ARKIN BUILDING FOR MARTIN TECHNOLOGIES, JSP15-74

Public hearing at the request of Irwin Arkin, LLC on behalf of the current occupant Martin Technologies for approval of Preliminary Site Plan and Special Land Use Permit for Arkin Building for Martin Technologies, JSP 15-74. The subject property is currently zoned I-1, Light Industrial and is located in Section 26, east of Novi Road and North of Nine Mile Road. The applicant is requesting a Special Land Use Permit for proposing outside storage that is related to the current use of the existing building on site. No additional improvements to the site are being proposed.

PROPOSED LIGHT INDUSTRIAL DISTRICT (I-1) ACCESSORY OUTSIDE STORAGE PLAN

PLAN REVIEW CENTER REPORT
January 22, 2016
Planning Review
ARKIN BUILDING FOR MARTIN TECHNOLOGIES
JSP15-74

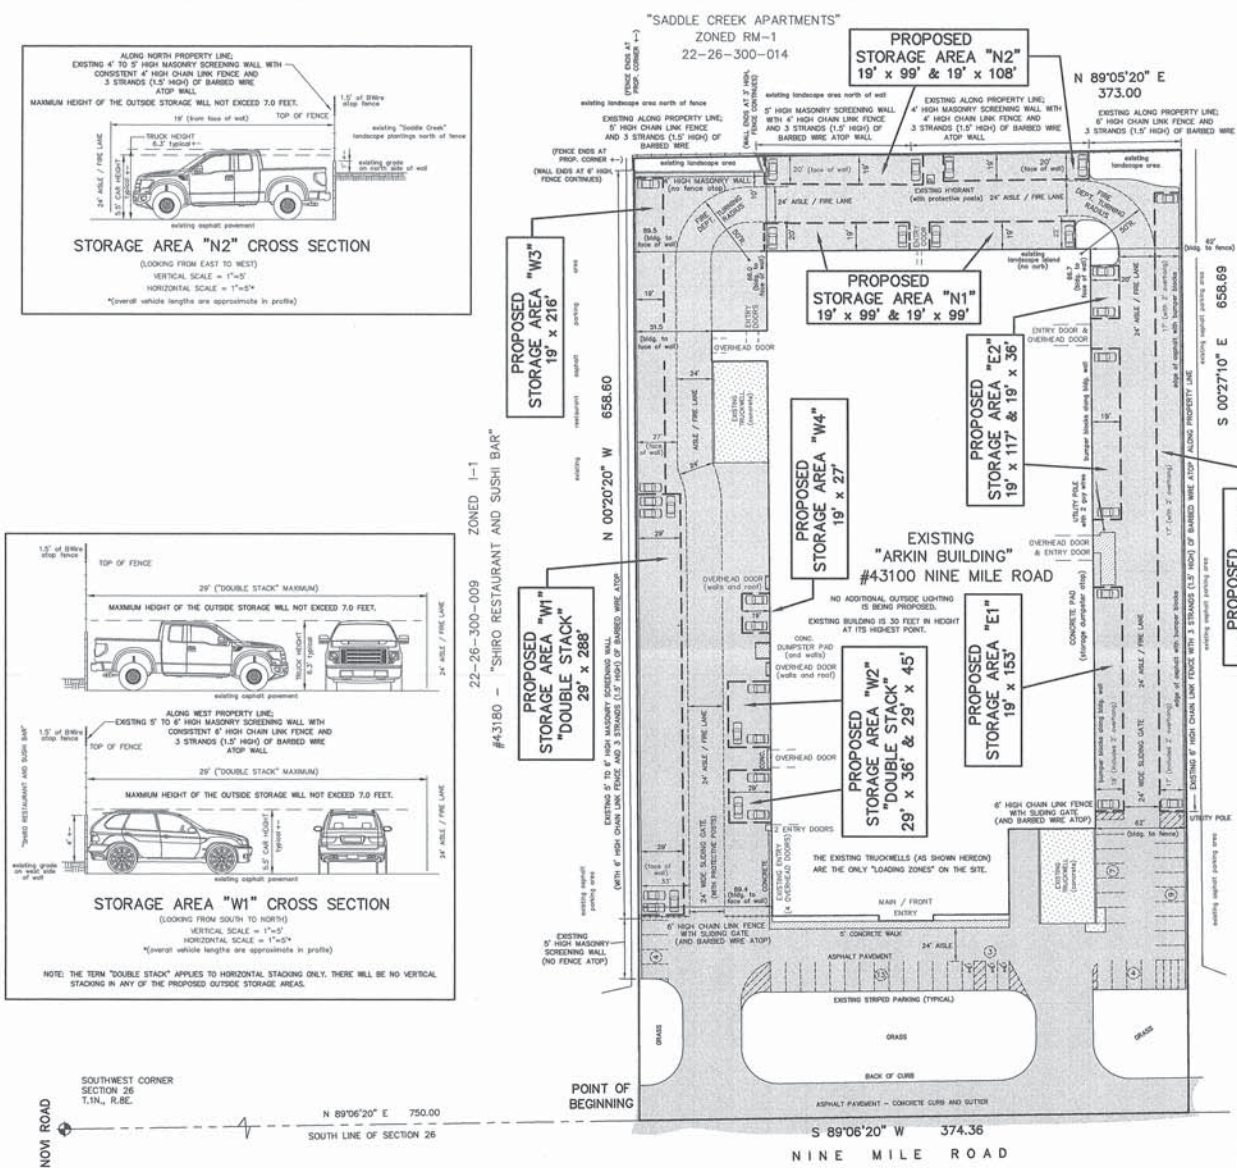
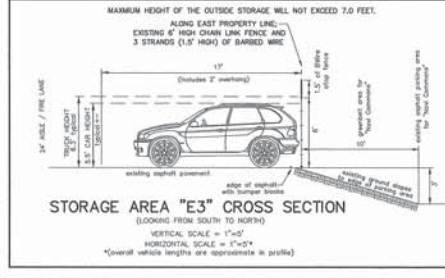
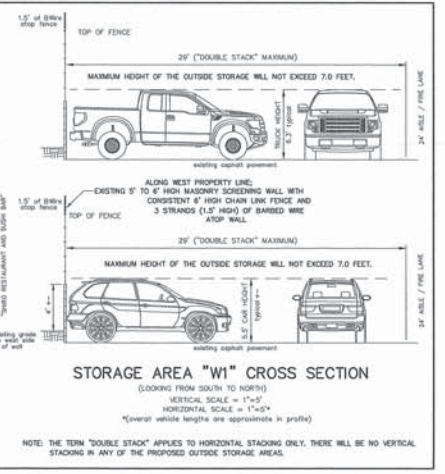
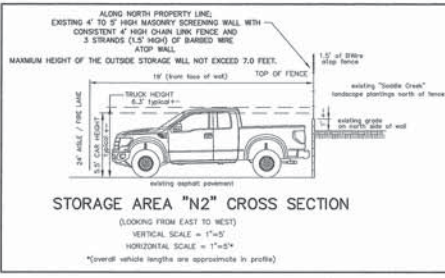
- a. The site plan does not propose any additional improvements to the existing conditions on the site. While the existing conditions were allowed as part of the temporary special land use, they do not meet the requirements for screening according to recent text amendment to allow outside storage in light industrial districts. **The current screening is not grandfathered and additional screening will be required, as determined by the Planning Commission.** The applicant indicated in his response letter that a justification will be provided at the Planning Commission meeting.

- b. The applicant has provided multiple pictures of existing trees surrounding the site. However, a majority of the plantings are not located on the subject property, but are on adjacent properties. **Staff went on a site visit to observe visibility of the outside storage from adjacent residential development. The outside vehicular storage is clearly visible. The existing chain-link fence does not provide adequate screening. Please refer to the Landscape Review Letter for additional detail.**

4. Means of Weather Protection (Sec. 3.14.1.B.iv.i): All outside storage materials shall be protected from damage due to weather precipitation as necessary. **The applicant added a note stating that no means of protection from weather are proposed. Please revise the plans to meet the requirements of the code.**

3. **The screening of all walls should be raised sufficiently to block the view of the tank and the vehicles. Either the walls should be raised to a final height of 6-8 feet to block the view of the vehicles, or the chain link fences should be replaced with materials such as wood or vinyl to provide 80-90% opacity to a height between 6-8 feet as measured from the pavement.**

4. **Screening composed of a wall, an opaque fence or evergreen shrubs growing to a height of at least 6 feet, should be placed along the section of the north property line where there is no existing wall. If landscaping is used, the species used should be proper for the conditions (i.e. shady), and maintained such that the required opacity is preserved over time. A plan for the maintenance of any proposed living landscape material should be submitted as part of the approved site plan.**

1. **Loading zone(s) should be designated as such on plan.**
2. The screening noted above will provide necessary loading zone screening.

All the relevant notations on the Plan pertaining to the fence(s) have been revised to include "3 strands (1.5' high) of barbed wire atop".

The Cross Section details also now show the barbed wire.

All issues relating to screening (plantings, opaque characteristics, etc.) will be addressed in our presentation to the Planning Commission. As noted on page 3 of the "Planning Review Chart," we intend to request modifications to the standards from the Planning Commission on all landscape questions.

The only Loading Zones on the site are the two truckwell locations that are shown on the Plan. A note has been added to the Plan near the front entry of the building to highlight this.
